Situation Report

PROJECT TITLE: 14-20 Stow Hill

SITE ADDRESS : 14-20 Stow Hill, Newport, NP20 1JB

Date: 3rd October 2023

Recommended Locations of Bat and Bird Enhancements:

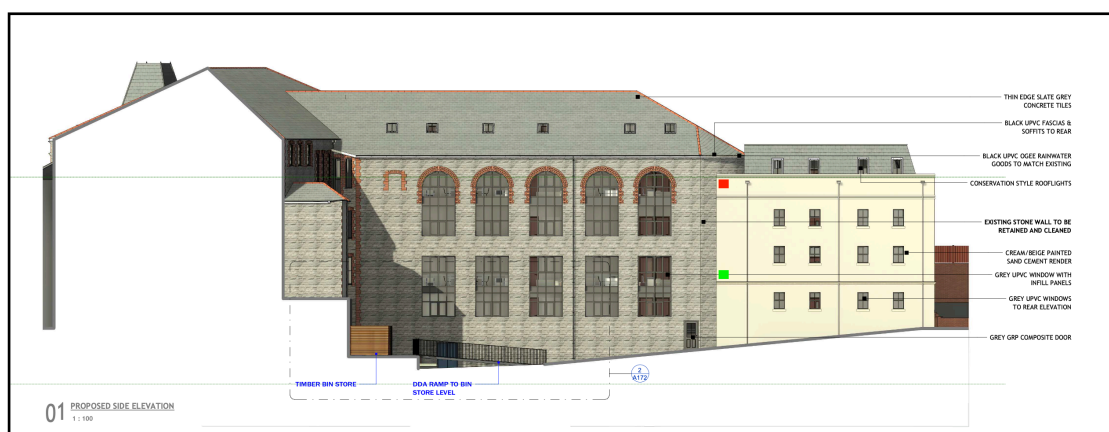
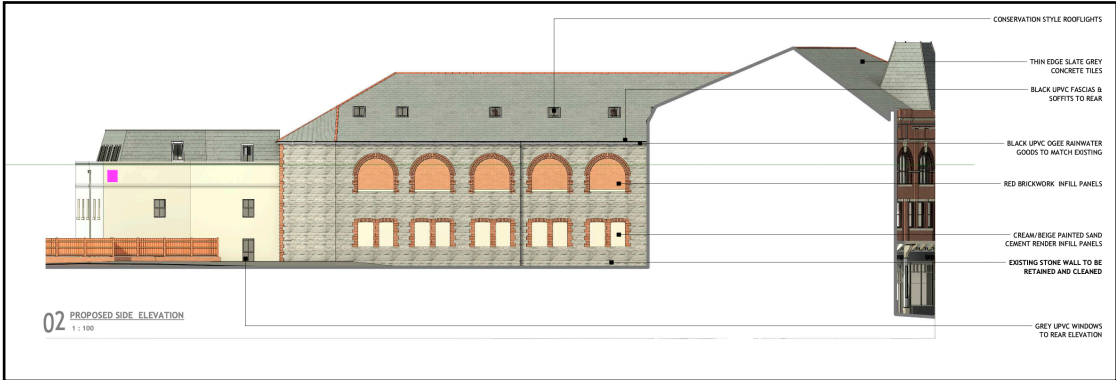
New roosting for bats will be created by building 2 Schwegler 1FR Bat Tubes into the block work of the new rendered extension. These can be rendered over and painted to match the finish of the building. Care must be taken to leave the access/egress slots at the bottom exposed for access. These will be fitted as high as possible on the southern and western elevations of the new extension.

Two 1SP Schwegler Sparrow Terraces will be built into the block work on the northern and western elevations of the new rendered extension. **These will not be situated on a south facing elevation.** Care must be taken not to obstruct the entrance holes during the rendering process.

Two No.16 Schwegler Swift Boxes will be built into the block work on the northern and western elevations of the new rendered extension. **These will not be situated on a south facing elevation.** Care must be taken not to obstruct the entrance holes during the rendering process.

Where practical, all bat features should be located far enough from any windows to avoid any direct light spill, at least a minimum of 2 metres away.

To comply with the Environment (Wales) Act 2016, ecological gain will be included into the scope of works. **All proposed enhancements will need to be added to architectural drawings.** This will consist of:
